PROPOSED TECHNICAL SPECIFICATION

ENTERGY OPERATIONS, INC.

ARKANSAS NUCLEAR ONE, UNIT ONE

Subject: Arkansas Nuclear One - Unit 1
Docket No. 50-313
License No. DPR-51
Proposed Technical Specification Change Revising The Pressurizer Code Safety
As-Found Setpoint Tolerance

FIG. NO.
14-5

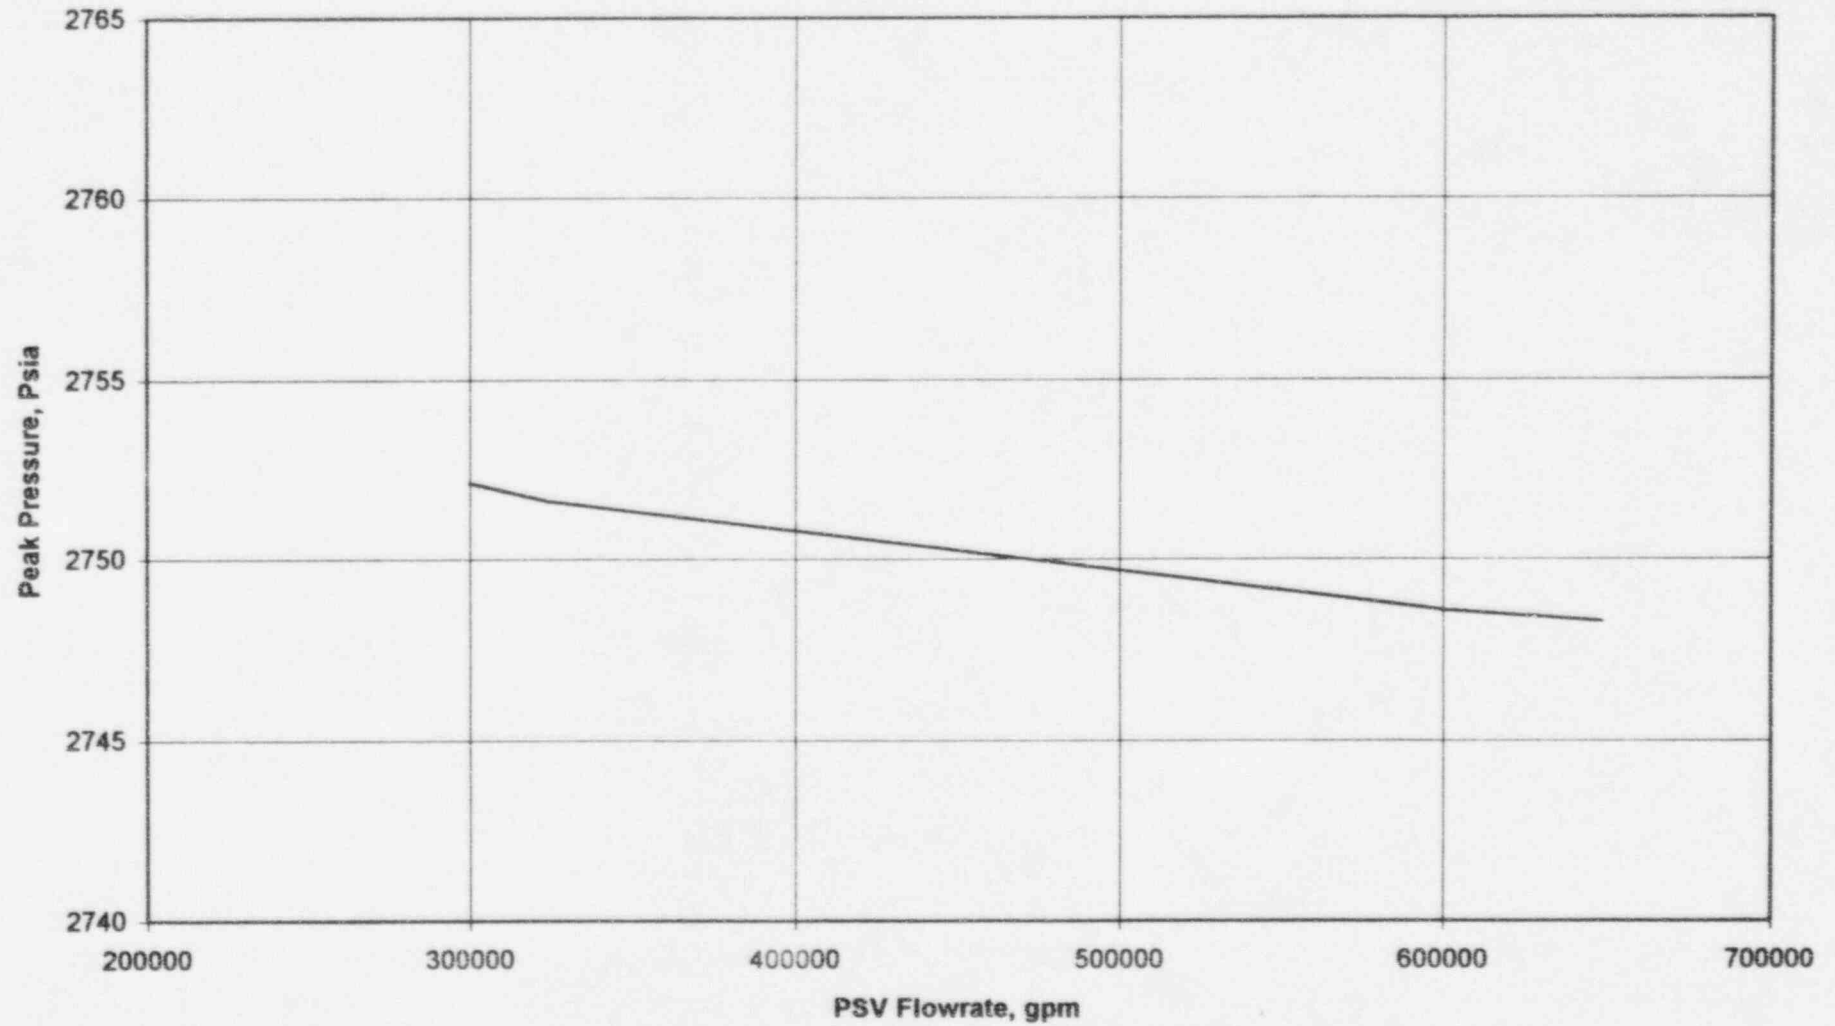
Figure 14-5 shows the effect of varying the pressurizer safety valve flow rate from a single PSV flow rate of 300,000 lbm/hr to 2 PSVs with a flow rate of 324,000 lbm/hr/valve.
